**PUBLIC WORKS ADDITION & RENOVATION**  
**CONTRACT NO. ENG2024-11191**

**Addendum No. 3**

**D6 SECTION**  
D1.1 1"=1'-0"

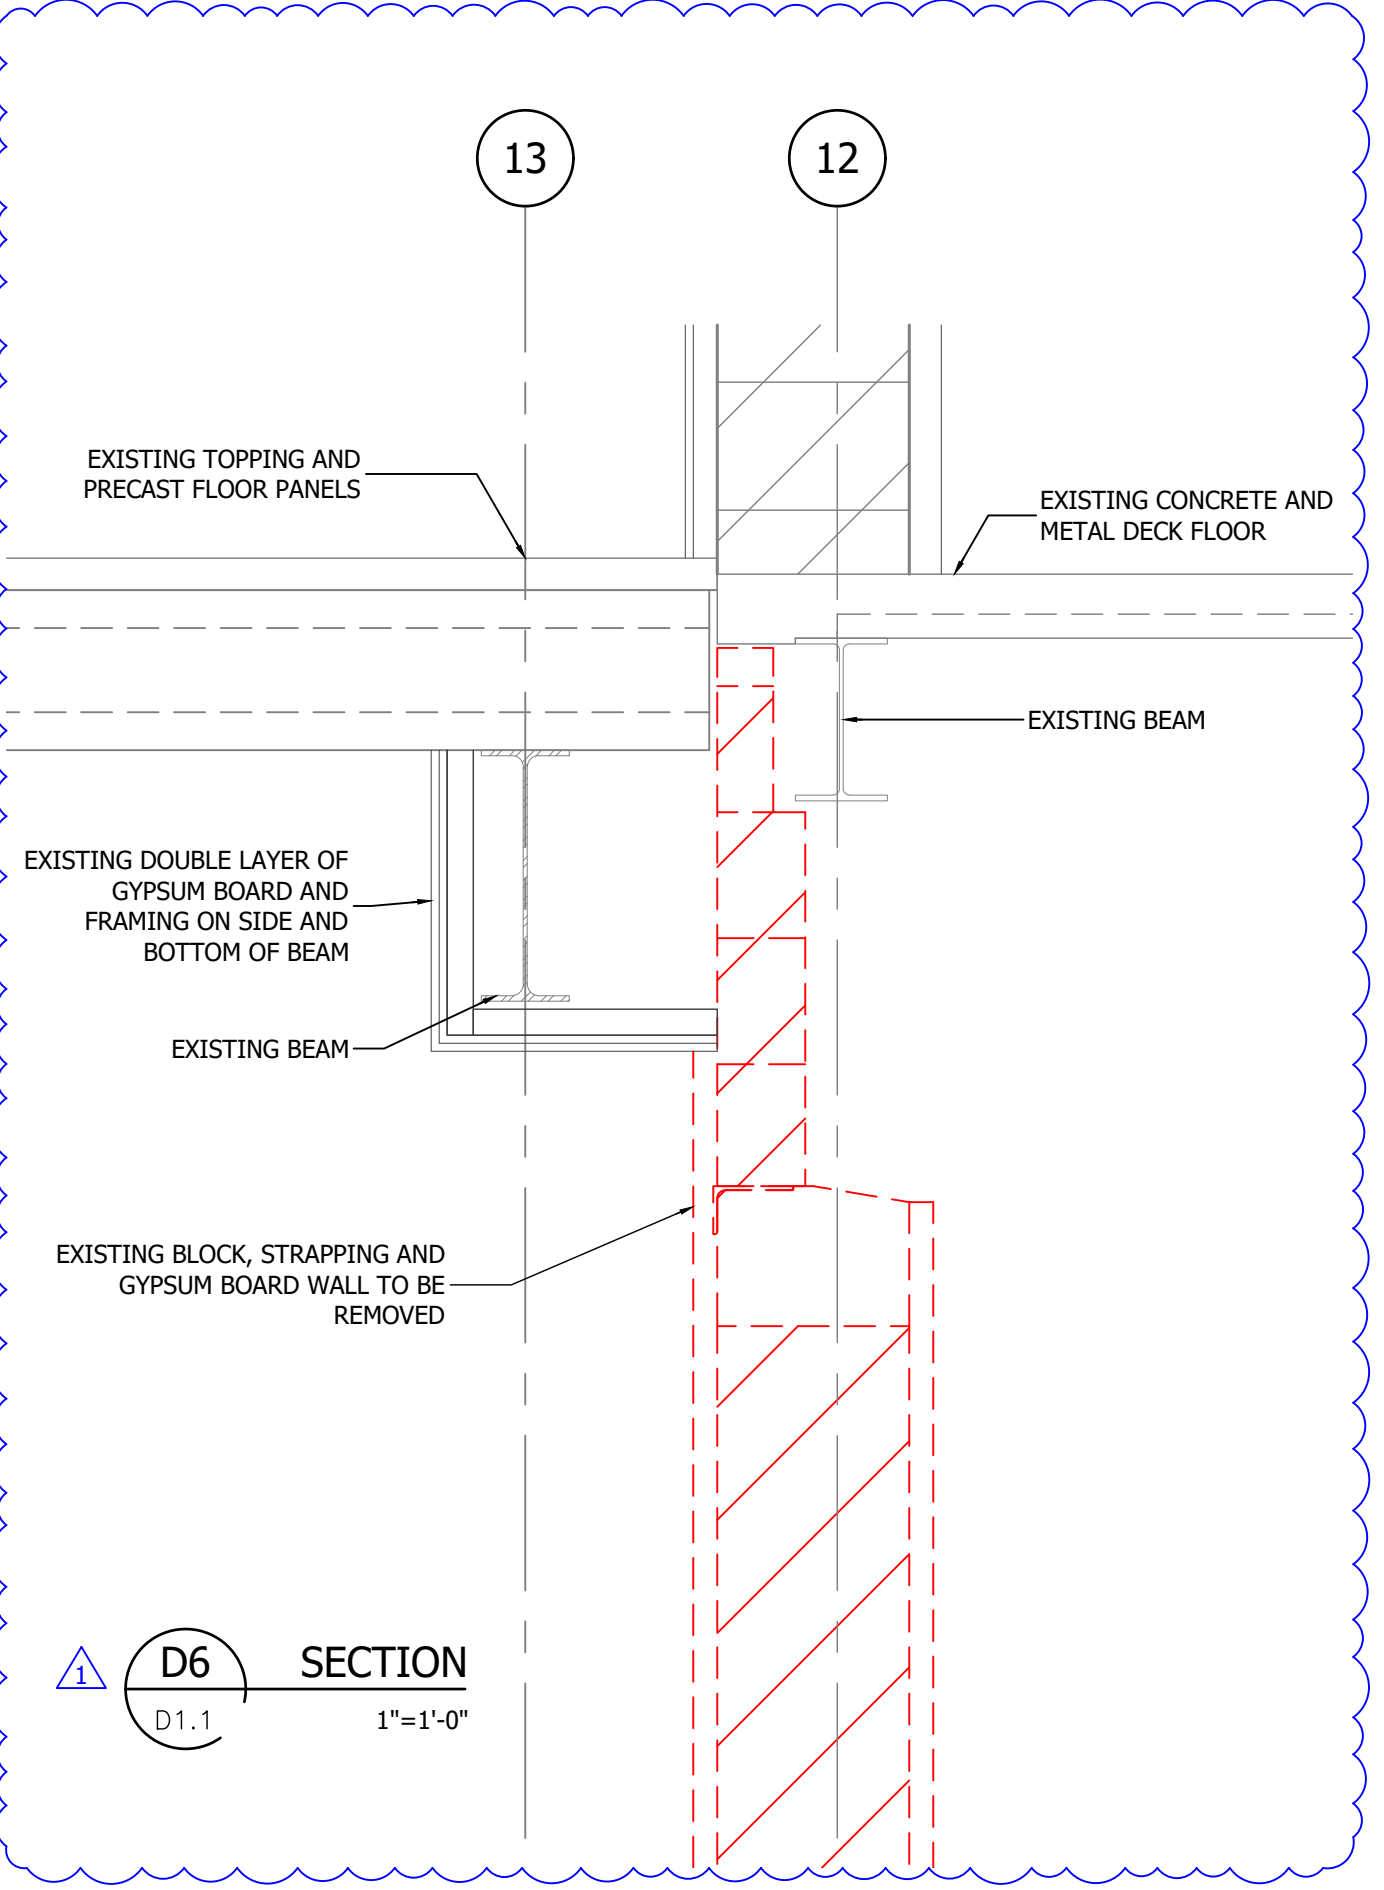
Additional drawings sections added for bulkhead and column in existing locker room, refer to attached drawing sheets.

REV.	BY	DESCRIPTION	DATE
1	PJV	ADD SECTION D6	2024-08-20
